**METROPOLITAN GOVERNMENT OF NASHVILLE AND DAVIDSON COUNTY**

**STAFF RECOMMENDATION**  
**1420 Calvin Avenue**  
**January 16, 2013**

**Application:** Demolition-partial; New Construction - addition and accessory structure  
**District:** Lockeland Springs-East End Neighborhood Conservation Zoning Overlay  
**Council District:** 06  
**Map and Parcel Number:** 08309027400  
**Applicant:** Rich McCoy, rem3studio  
**Project Lead:** Melissa Baldock, melissa.baldock@nashville.gov

<p><b>Description of Project:</b> Applicant proposes to demolish an existing addition and to construct a new addition and accessory structure.</p> <p><b>Recommendation Summary:</b> Staff recommends approval of the addition and accessory structure, with the condition that staff approve the roof color, the final door and window specifications, the paint color for the brick, and the exterior stair material. With the final approval of the materials, staff finds that the addition and accessory structure meet the applicable design guidelines for the Lockeland Springs-East End Neighborhood Conservation Zoning Overlay.</p>	<p><b>Attachments</b> <b>A:</b> Site Plan <b>B:</b> Elevations</p>
--	--

SITE PLAN

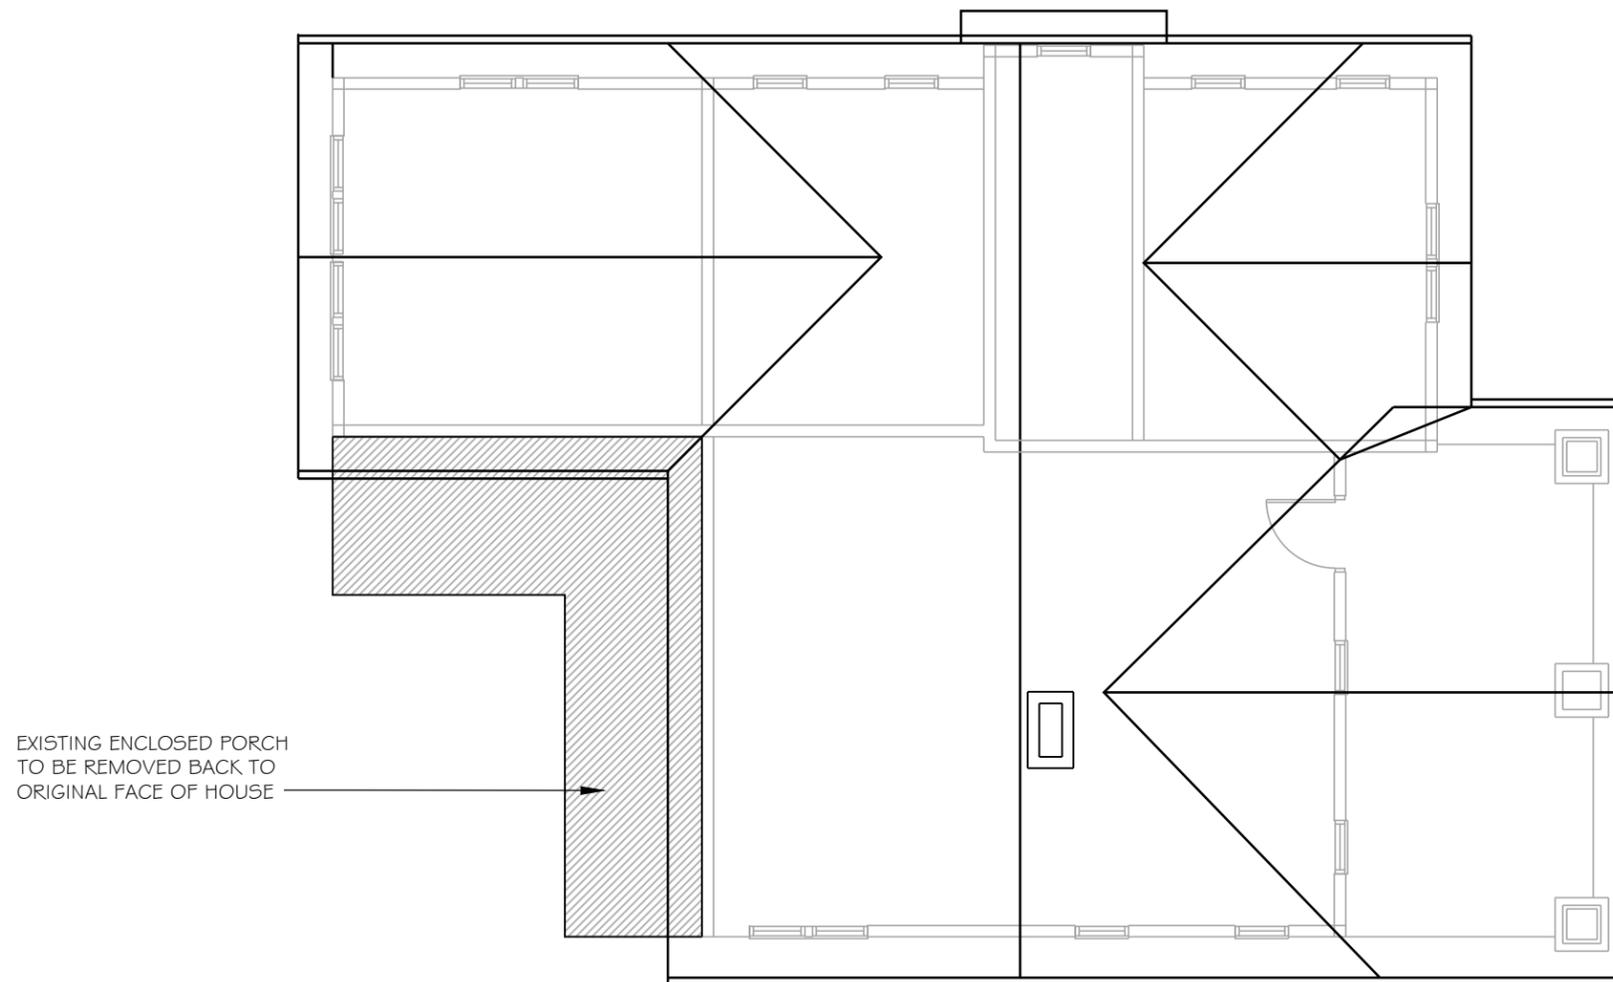
Demolition: The project involves removing an existing one hundred and thirty-five square foot (135 sq. ft.) enclosed porch at the rear of the structure (see Figure 2). The structure does not appear to be original to the structure because it has a concrete block foundation that does not match the brick foundation of the main portion of the house (see Figure 3). The structure lacks historic and architectural integrity, and staff finds that its removal meets Section IV.B. of the design guidelines.

EXISTING ENCLOSED PORCH  
TO BE REMOVED BACK TO  
ORIGINAL FACE OF HOUSE

EAST ELEVATION - PROPERTY

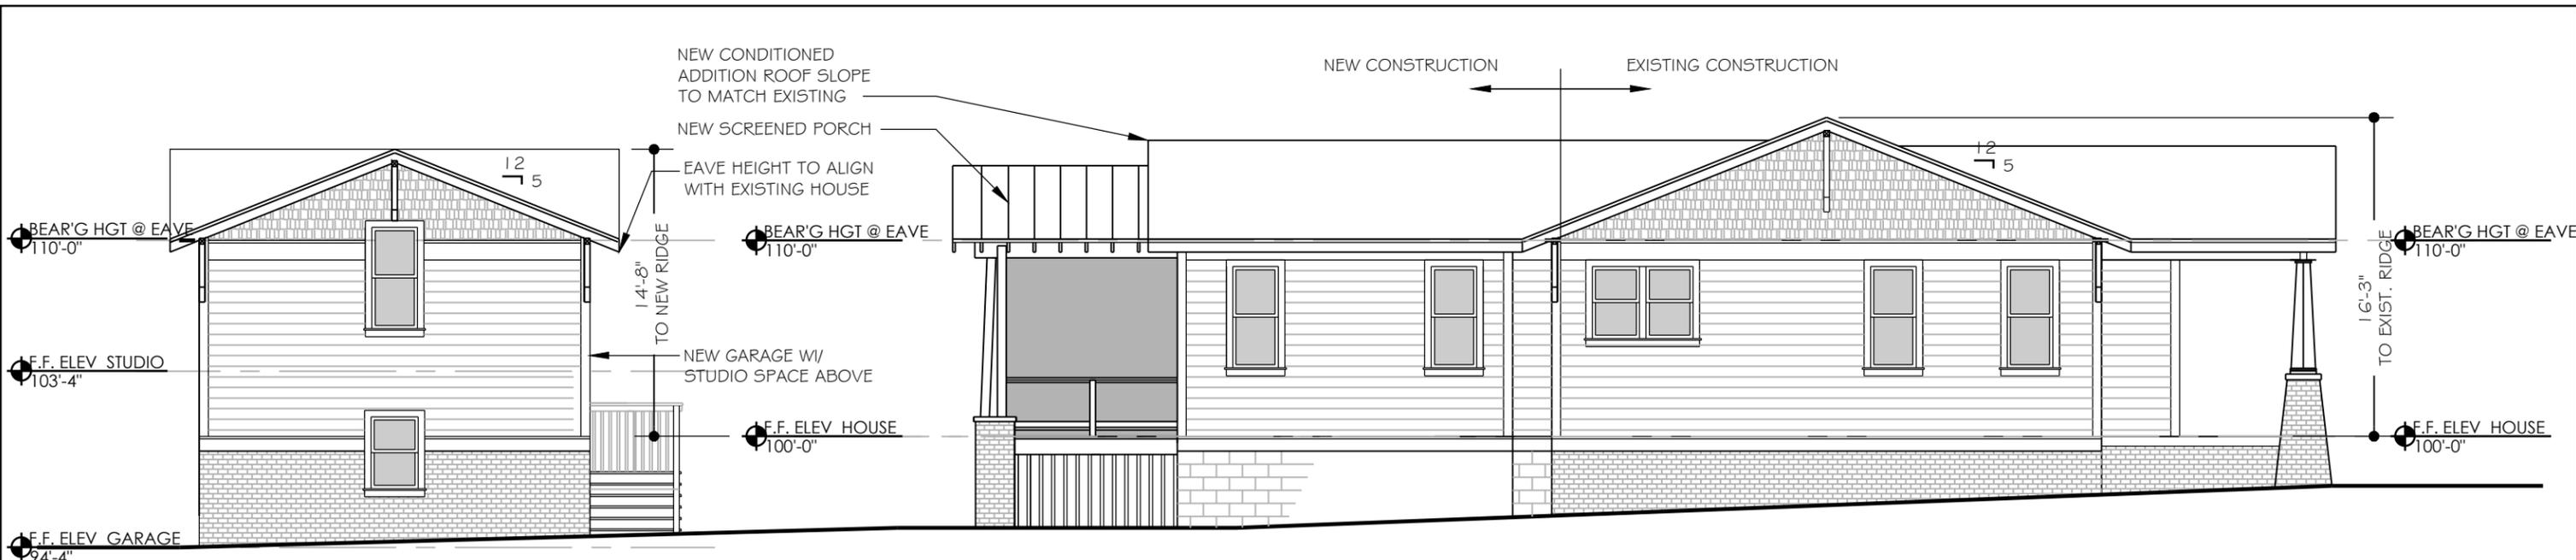
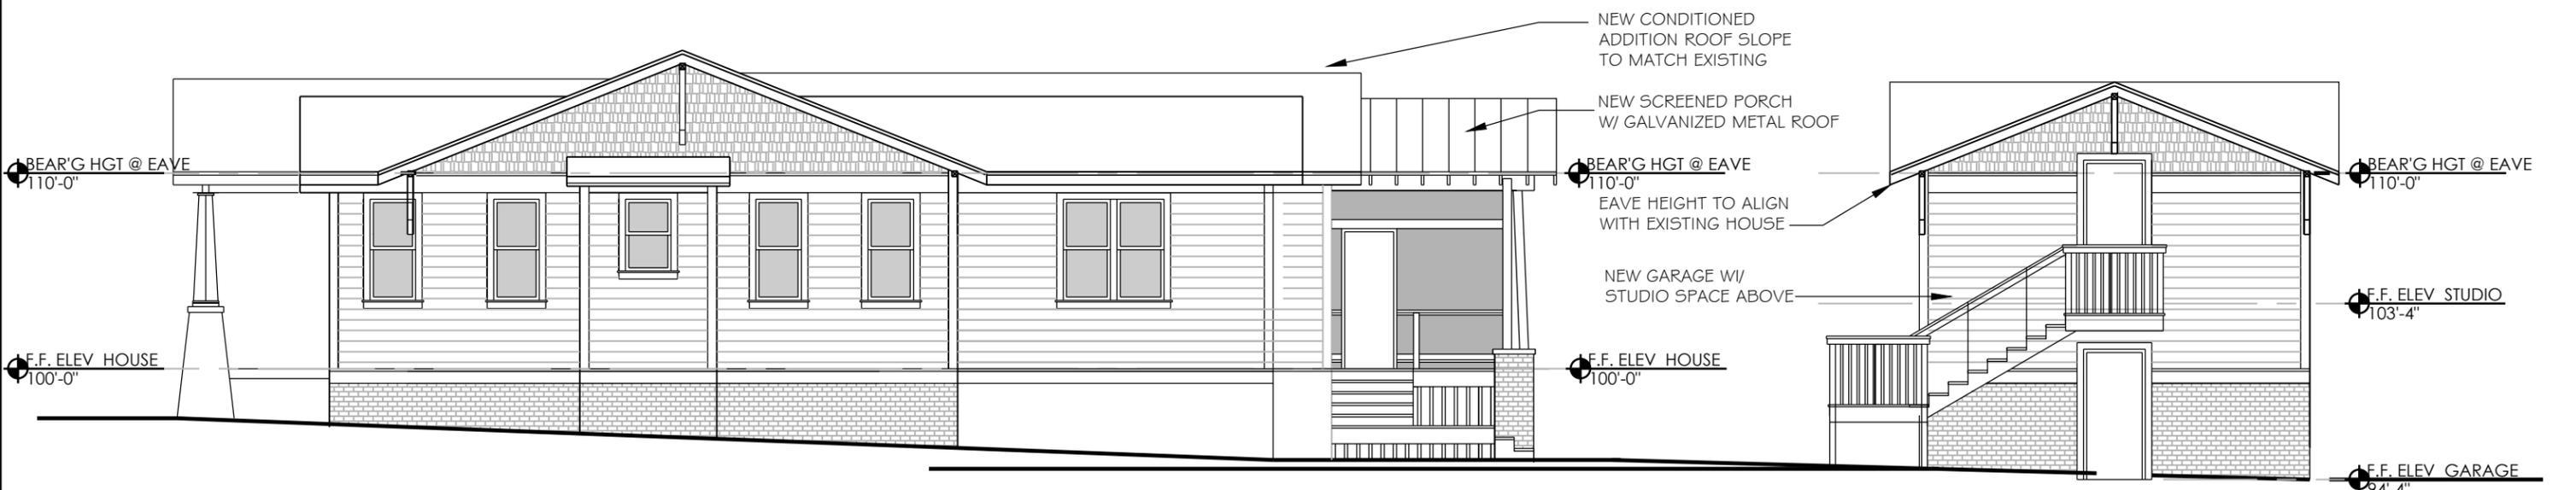
Location, Setback: The proposed addition is located entirely behind the existing house and meets all base zoning requirements for setbacks. The addition will largely match the line of the house, and will be at least five feet (5') from the side property line. Staff therefore finds that the location and setback for the proposed addition meet Section II.B.3. and II.B.10. of the design guidelines.

Height, Scale: The existing house has a ridge height of approximately sixteen feet, three inches (16'3") above the foundation line. The addition's eave height will match that of the historic house, but the ridge of the bulk of the addition will be approximately one foot (1') lower than that of the house, or approximately fifteen feet, three inches (15'3") above the foundation line. The screened porch portion of the addition will be lower in height and will be approximately fourteen feet (14') above the foundation.

The addition steps in one foot (1') from the east side wall of the house for a depth of two feet (2'). After that inset, it steps back out to line up with the east side wall of the house. The addition has a maximum width of twenty-two feet, four inches (22'4") and a maximum depth of twenty-nine feet, three inches (29'3"). It will be approximately five hundred and forty square feet (540 sq. ft.).

The primary cladding material for the new addition will be wood or cement fiberboard with a reveal to match that of the house. Cedar shake will be used in the rear gable field. The foundation will be split-face concrete block, and the roof will be asphalt shingle. Staff asks to approve the asphalt shingle color prior to purchase and installation. The windows will be aluminum clad wood windows, and staff asks to approve all new window and door specifications prior to purchase and installation. The porch will be screened and will have stained or painted wood columns with painted brick column bases and precast concrete caps. Staff asks to approve the brick paint color to ensure its appropriateness. The porch will also have a stained or painted wood apron panels in between its column bases. With the final approval of the asphalt shingle color, windows, doors, and brick paint color, staff finds that the structure's materials meet Sections II.B.4. and II.B.10. of the design guidelines

Roof Form: The existing house's primary roof form is a cross gable with a slope of 5:12. The addition's roof form will also be a gable with a slope of 5:12. Staff finds that the roof form is compatible with that of the house and with surrounding historic structures, and meets Sections II.B.5. and II.B.10. of the design guidelines.

Proportion and Rhythm of Openings: The drawings indicate that the window and door openings on the existing structure will not be altered as part of this project. The windows on the addition are twice as tall as they are wide, and there are no large expanses of wall space without a door or window opening. Staff finds that the addition's proportion and rhythm of openings meet Section II.B.7. and II.B.10. of the design guidelines.

NORTH ELEVATION - HOUSE

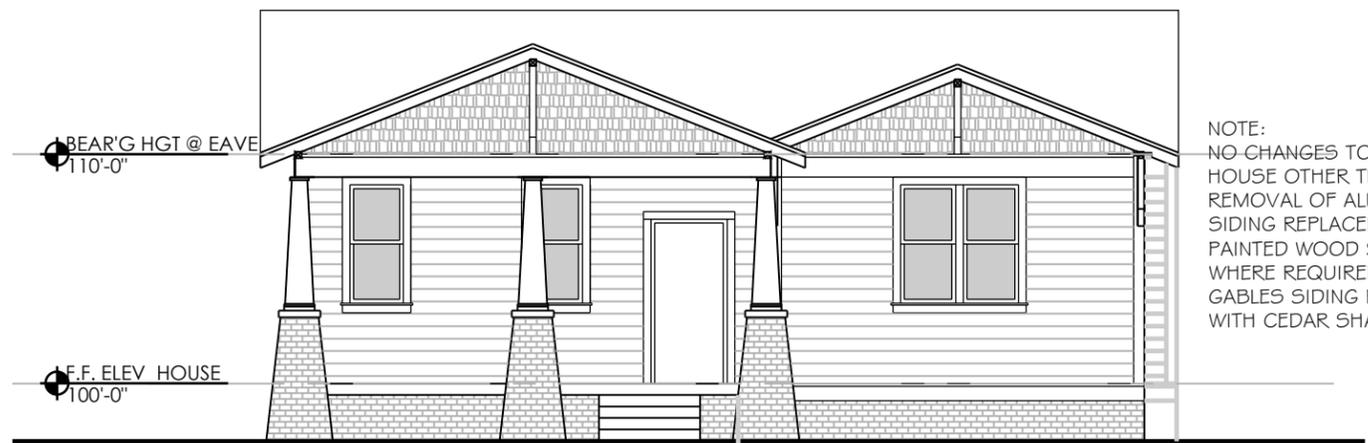
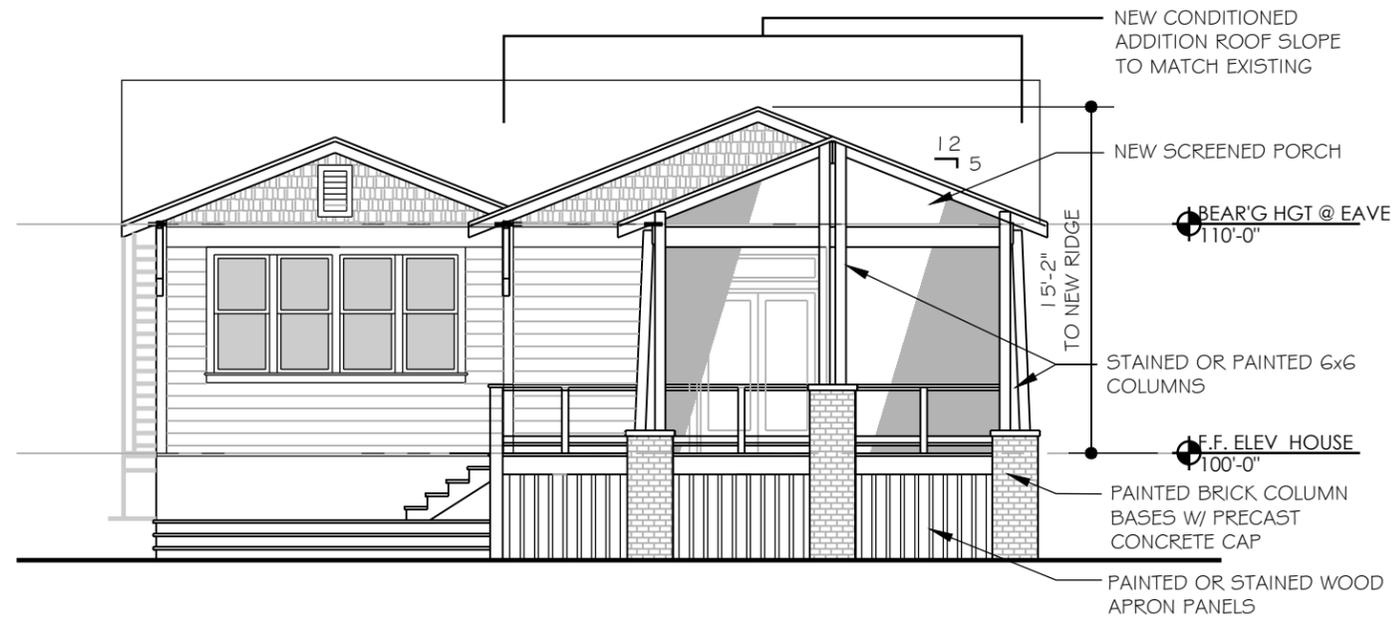
Materials: The project involves removing some existing, non-historic materials on the existing house. Aluminum siding will be removed from the house's gables on its front, side and rear facades (see Figures 4-7). The aluminum siding will be replaced with cedar shake. The house's wood siding and trim will largely be retained, although in-kind replacement may occur in spots where necessary.

NOTE:  
NO CHANGES TO FRONT OF HOUSE OTHER THAN REMOVAL OF ALUMINUM SIDING REPLACEMENT OF PAINTED WOOD SIDING & TRIM WHERE REQUIRED AND GABLES SIDING REPLACED WITH CEDAR SHAKE

NORTH ELEVATION - GARAGE

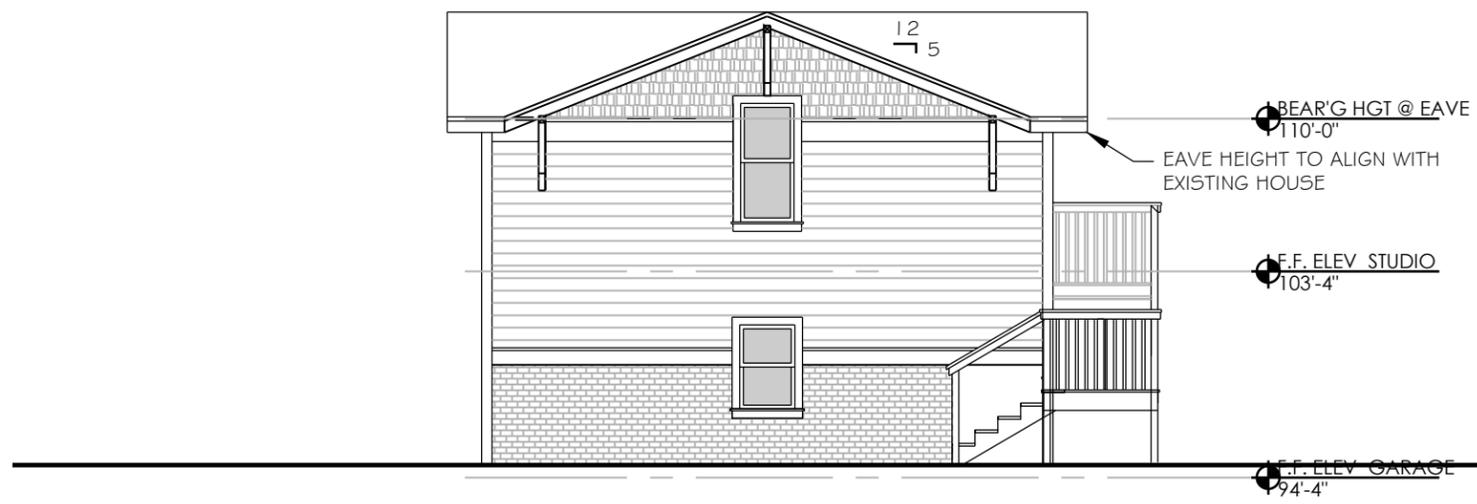
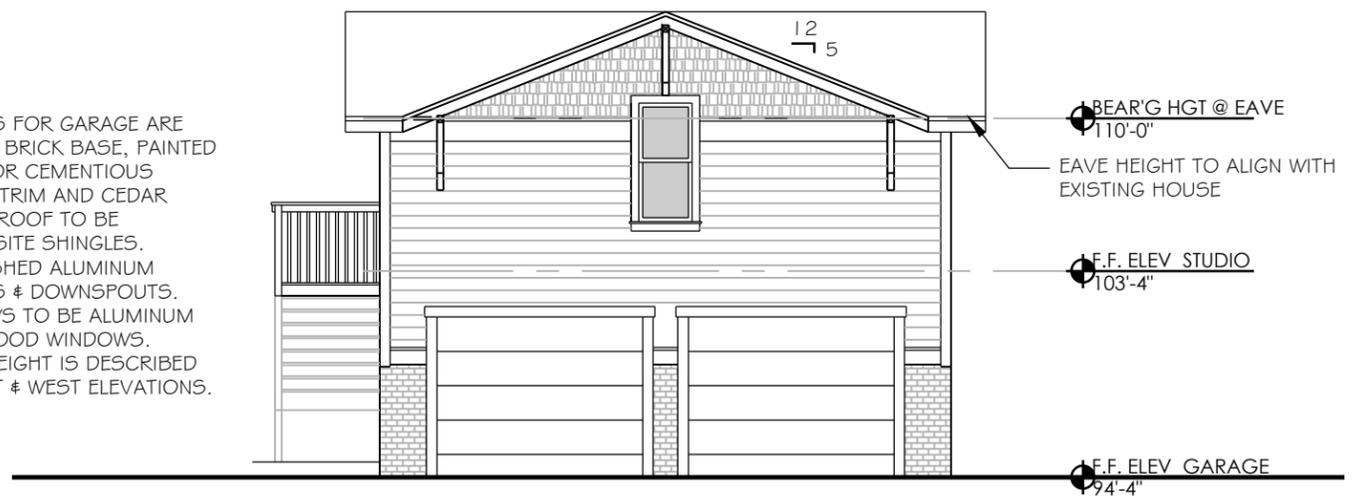
The materials for the accessory structure include wood or cement fiberboard siding and trim, cedar shake in the gable fields, aluminum clad windows, a painted brick foundation, and an asphalt shingle roof. The materials for the exterior stairs and vehicular doors were not specified. The roof form will be gabled with a slope of 5:12 to match that of the house. The window and door openings are appropriate for an accessory structure.

NOTE:  
FINISHES FOR GARAGE ARE PAINTED BRICK BASE, PAINTED WOOD OR CEMENTIOUS SIDING, TRIM AND CEDAR SHAKE. ROOF TO BE COMPOSITE SHINGLES. PREFINISHED ALUMINUM GUTTERS & DOWNSPOUTS. WINDOWS TO BE ALUMINUM CLAD WOOD WINDOWS. RIDGE HEIGHT IS DESCRIBED ON EAST & WEST ELEVATIONS.

Staff recommends approval of the addition and accessory structure, with the condition that staff approve the roof color, the final door and window specifications, the paint color for the brick, and the exterior stair material. With the final approval of the materials, staff finds that the addition and accessory structure meet the applicable design guidelines for the Lockeland Springs-East End Neighborhood Conservation Zoning Overlay.
